Intersection ID: 49557	Main Street: STEEL_YARD_CT	Cross Street: WARREN_BURGESS_LN	Location:	NW
ADA ID: 6ABDB8298B97	Ramp Type: Perp	Initial Pass/Fail: Fail	Overall Compliance: No	Severity Score: 33.75

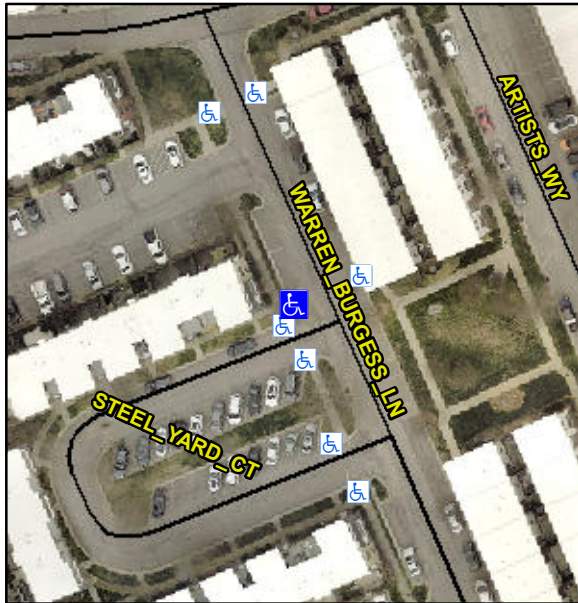
Not Found, R304.5.1, R304.2.2

Compliance	Description	Data	Compliance	Description	Data
N/A	Ramp Length (in)	60.0	No	Ramp Slope (%)	15.7
No	Ramp Width (in)	47.0	Yes	Ramp XSlope (%)	1.8
N/A	Flare Type LT	N/A	N/A	Flare Type RT	N/A
N/A	Flare Slope LT (%)	N/A	N/A	Flare Slope RT (%)	N/A
N/A	Flare Traversable LT?	N/A	N/A	Flare Traversable RT?	N/A
N/A	Landing Length (in)	N/A	N/A	DWS Provided?	N/A
N/A	Landing Width (in)	N/A	N/A	DWS Contrast?	N/A
N/A	Landing Slope (%)	N/A	N/A	DWS Length (in)	N/A
N/A	Landing X Slope (%)	N/A	N/A	DWS Full Width?	N/A
N/A	Landing Curb? (Y/N)	N/A	N/A	DWS Offset (in)	N/A
N/A	Shared Landing?	N/A			
N/A	Gutter Ponding?	N/A	N/A	Gutter Slope (%)	N/A
N/A	Gutter Lip Ht (in)	N/A	N/A	Gutter X Slope (%)	N/A
N/A	Painted X Walk1?	No	N/A	Painted X Walk2?	N/A
	X Walk 1 Direction	To E		X Walk 2 Direction	N/A
N/A	X Walk 1 Width (in)	N/A	N/A	X Walk 2 Width (in)	N/A
	X Walk 1 Slope (%)	2.2		X Walk 2 Slope (%)	N/A
	X Walk 1 X Slope (%)	0.0		X Walk 2 X Slope (%)	N/A

Remove & Replace Entire Ramp.
